# Access Compliance Report

## Public Rights-of-Way

Intersection ID: N/A	Main Street: CITY_PARK_DR	Cross Street: TYVOLA_RD	Location: NW
ADA ID: 58757DE3EB16	Ramp Type: Perp	Initial Pass/Fail: Fail	Overall Compliance: No
			Severity Score: 21.25

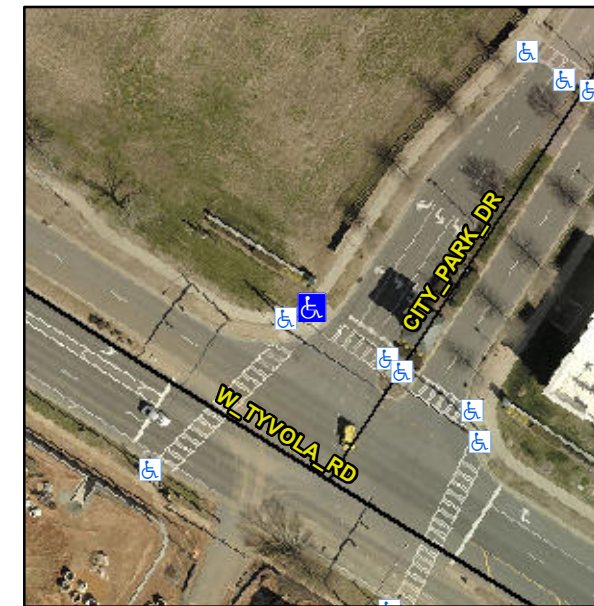
**Not Found, R304.5.1, R304.2.2**

Compliance	Description	Data	Compliance	Description	Data
N/A	Ramp Length (in)	97.0	No	Ramp Slope (%)	9.1
No	Ramp Width (in)	47.0	Yes	Ramp XSlope (%)	2.0
N/A	Flare Type LT	N/A	N/A	Flare Type RT	N/A
N/A	Flare Slope LT (%)	N/A	N/A	Flare Slope RT (%)	N/A
N/A	Flare Traversable LT?	N/A	N/A	Flare Traversable RT?	N/A
N/A	Landing Length (in)	N/A	N/A	DWS Provided?	N/A
N/A	Landing Width (in)	N/A	N/A	DWS Contrast?	N/A
N/A	Landing Slope (%)	N/A	N/A	DWS Length (in)	N/A
N/A	Landing X Slope (%)	N/A	N/A	DWS Full Width?	N/A
N/A	Landing Curb? (Y/N)	N/A	N/A	DWS Offset (in)	N/A
N/A	Shared Landing?	N/A			
N/A	Gutter Ponding?	N/A	N/A	Gutter Slope (%)	N/A
N/A	Gutter Lip Ht (in)	N/A	N/A	Gutter X Slope (%)	N/A
N/A	Painted X Walk1?	Yes	N/A	Painted X Walk2?	N/A
	X Walk 1 Direction	To SE		X Walk 2 Direction	N/A
N/A	X Walk 1 Width (in)	112.0	N/A	X Walk 2 Width (in)	N/A
	X Walk 1 Slope (%)	2.0		X Walk 2 Slope (%)	N/A
	X Walk 1 X Slope (%)	1.2		X Walk 2 X Slope (%)	N/A

**Remove & Replace Entire Ramp.**
